**REPORT ON APPLICATION FOR PRELIMINARY  
PLAT SUBDIVISION APPROVAL  
EAGLE'S CREST SUBDIVISION PHASES 5-9  
FPP-07-10**

**Submitted to:  
Flathead County Planning Board  
Public Hearing September 5, 2007**

**Prepared for:  
Flathead Lake Protection Association, and  
McGarvey, Heberling, Sullivan & McGarvey, PC**

**Prepared by:  
Kathleen McMahon (AICP), Applied Communications**

Figure 1: NRSC Soil Map

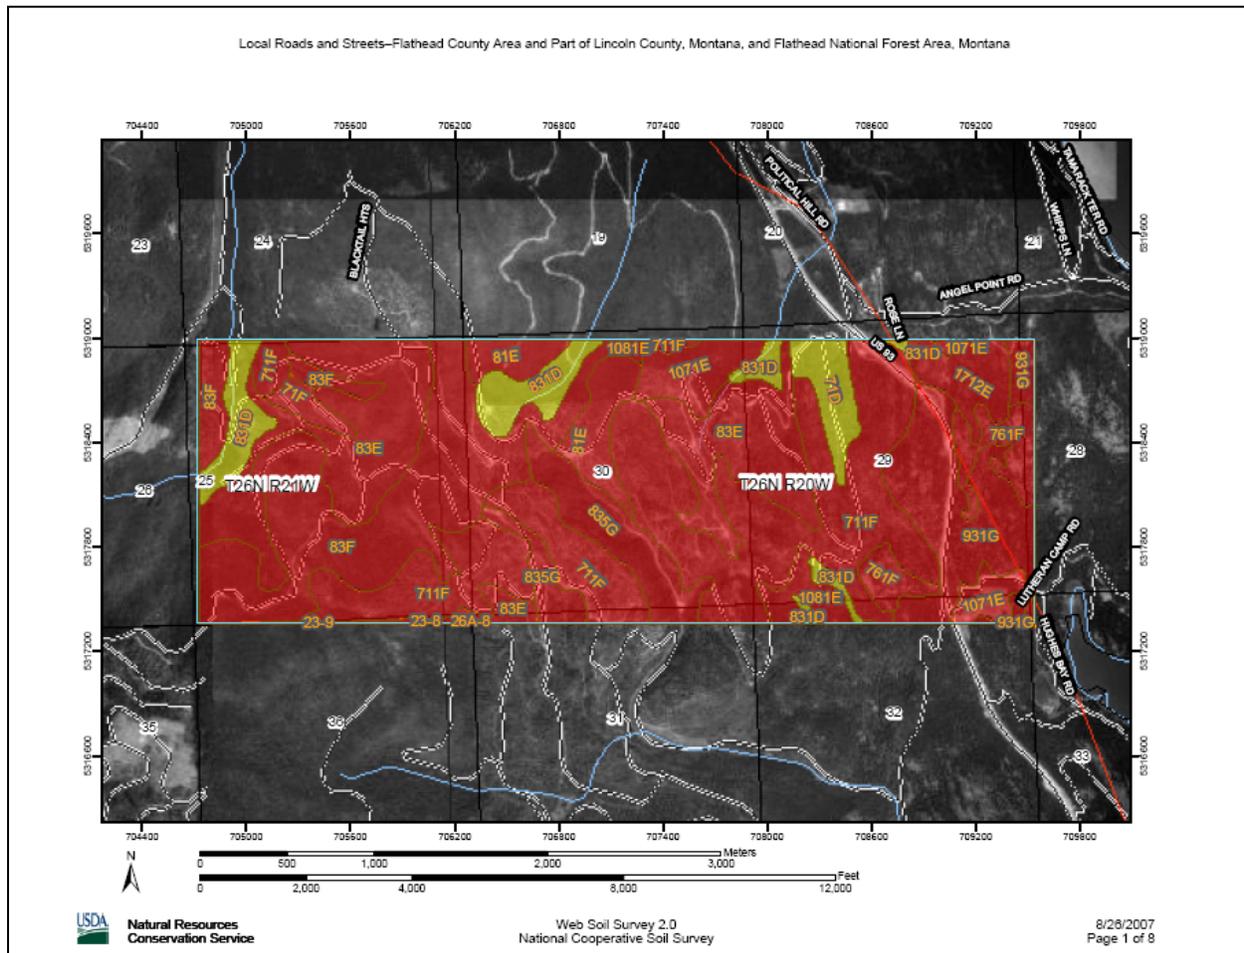
The NRCS rating for the site is “Very Limited” for a substantial majority of the site due to slope, depth to bedrock and frost action. (See Figure 1) Following is a description of this rating. The complete soil tables are included in the appendix

In respect to criteria (d) and (g) in Policy 4.12, the soil report for the site indicates that the site has limitations due to slope and frost action. In respect to criteria (f), although no sub-surface analysis has been completed to determine depth to bedrock, the memo from Morrison Maierle dated 8/15/07, notes, “...general depth to groundwater is discussed in the receding material, however, depth to bedrock or impervious material on the site may be minimal.” Additionally, The NRCS soil reports indicate that several soil types on site have a low depth to bedrock.

This analysis suggest that criteria (d), (e), (f) and (g) listed in Policy 4.12 are present on the site and provide limitations for developing roads which states that, “Soils which exhibits four or more of the following limitations should not be developed into roads.”

The NRCS rating for the site is “Very Limited” for a substantial majority of the site due to slope, depth to bedrock, shrink swell and frost action. (See Figure 1) Following is a description of this rating. The complete soil tables are included in the appendix (See Attachment A). It should be noted that a large portion of the soils on site have the **most negative** rating of 1.0 for slope and 1.0 for depth to bedrock.

In respect to the criteria in Policy 4.13, according to the NRCS soil report, many of the soils on the site have shrink-swell characteristics that negatively impact residential construction and meet criteria (a). In respect to criteria (d) large portions of the site have slopes over 15%. In respect to criteria (e), no sub-surface analysis has been completed to determine depth to bedrock. As noted in the memo from Morrison Maierle dated 8/15/07, however, the following is noted on pg. 2, “...general depth to groundwater is discussed in the receding material, however, depth to bedrock or impervious material on the site may be minimal.” This statement suggests that depth to bedrock may be less than 20 inches. Additionally, the NRCS soil reports indicate that several soil types on site have a low depth to bedrock.

This analysis suggests that four of the features listed in Policy 4.13 are present on the site and residential construction should be discouraged or have a limited density to lessen soil disturbance.

Figure 3 : Community Wildfire Fuels Reduction Plan. WUI and Communities at Risk Analysis

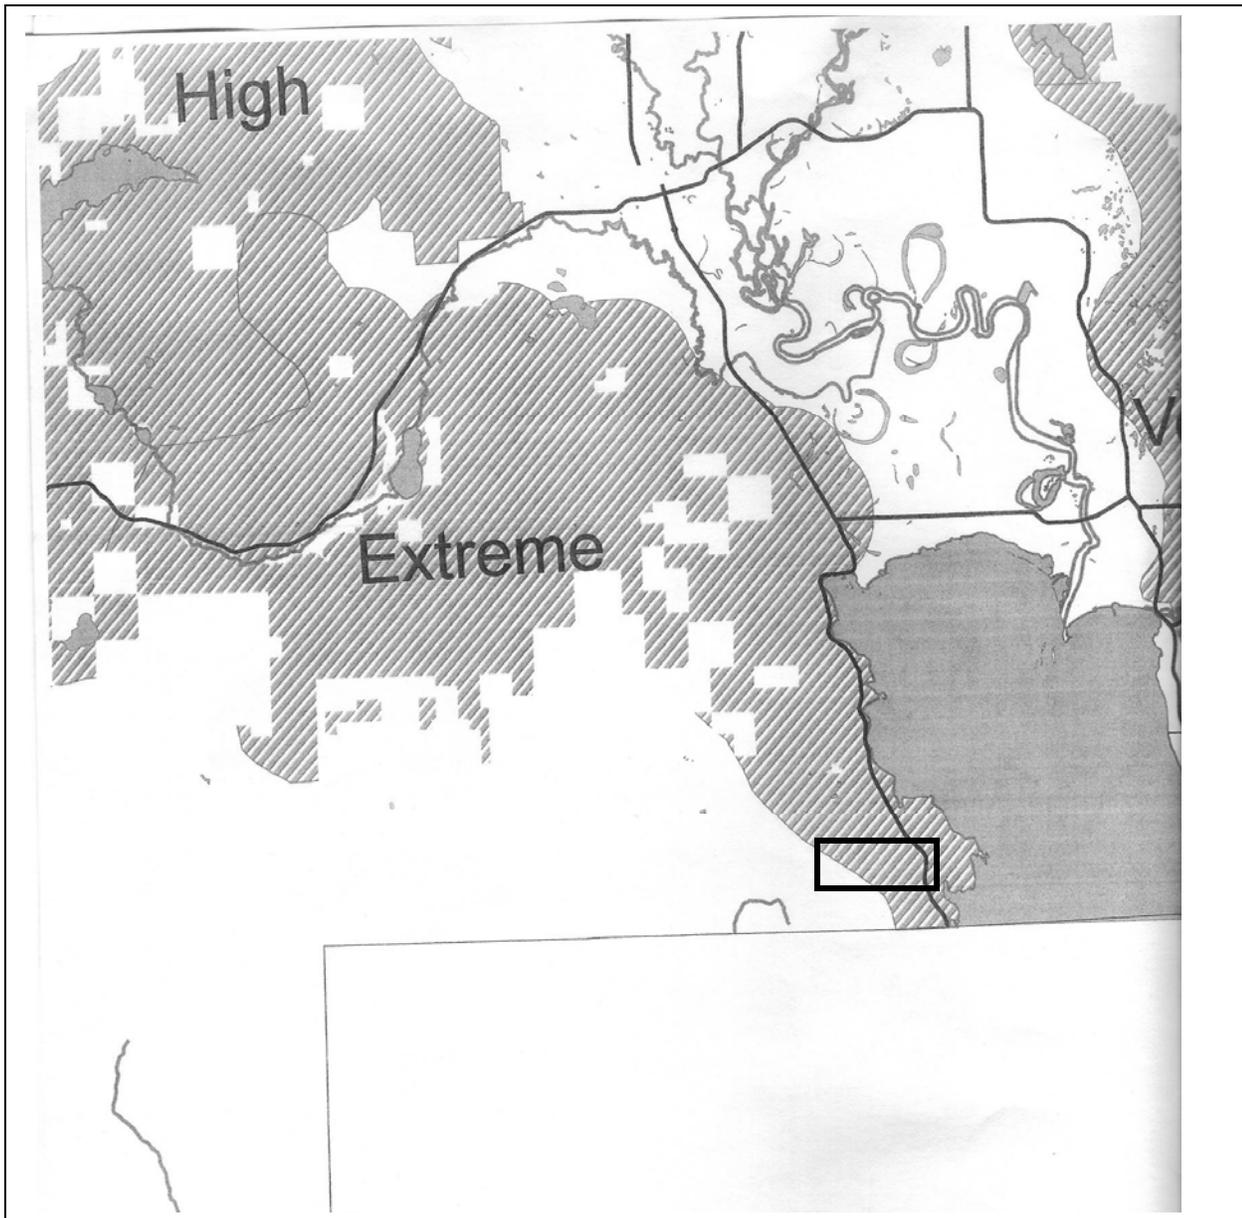
As noted in Figure 3 of this report, the subject property is located in an area that the Community Wildfire Fuels Reduction Plan (2005) classifies as “Extreme” Fire Risk Level. With this classification, the standard in Table 3 regarding cul-de-sac length in high hazard fire areas should apply. According to the information the following cul-de-sacs exceed the maximum length of 750’.

According to Figure 3, the development is located in an area that is classified as “Extreme” Fire Risk by the Community Wildfire Fuels Reduction Plan. The staff report notes that there are approximately 50 lots where the general topography exceeds 30%. Although the applicant submitted a slope analysis to locate building pads on each site, Section 3.21 **prohibits** building sites in high fire hazard areas.
